ROAD SAFETY AUDIT

Cahermurphy West Wind Farm, Co. Clare

Stage 1 Road Safety Audit

Figure 2.2 – Location Where Passing Motorists Could Access the Overrun Area (When Not in Use)

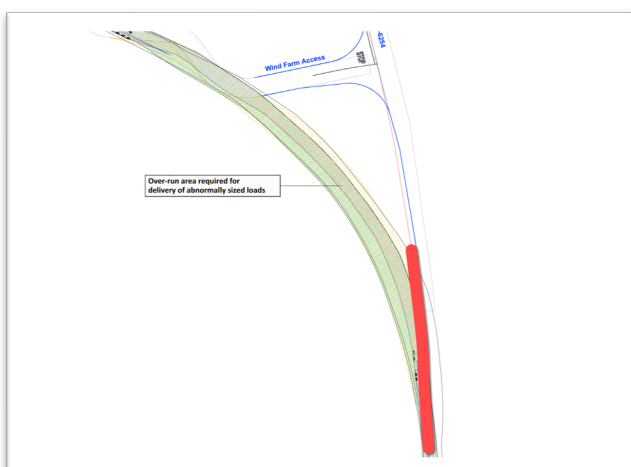
2.2 Problem: Passing Motorists Accessing the Via Overrun Area

Location: Overrun Area to South of L-6254 Access Road Junction

The over-run area might create confusion for passing motorists, who could access the overrun area by mistake, leading to sudden braking, loss of control or conflicts with construction traffic.

The Designer should ensure that a suitable barrier is put in place to prevent passing motorists from accessing the abnormal load overrun area when it is not in use.

Problem Reference (Section 2)	Designer Response Section			Audit Team Response Section
	Problem Accepted (yes / no)	Recommended Measure Accepted (yes / no)	Alternative Measures or Comments	Alternative Measures Accepted (yes / no)
2.1	Yes	Yes	The vegetation either side of the access junction will be removed as recommended.	Comment noted and accepted.
2.2	Yes	Yes	The over-run area for abnormally sized loads will be closed as a default and opened only on the nights that the abnormally sized loads are delivered, which will be accompanied with a Garda escort.	Comment noted and accepted.
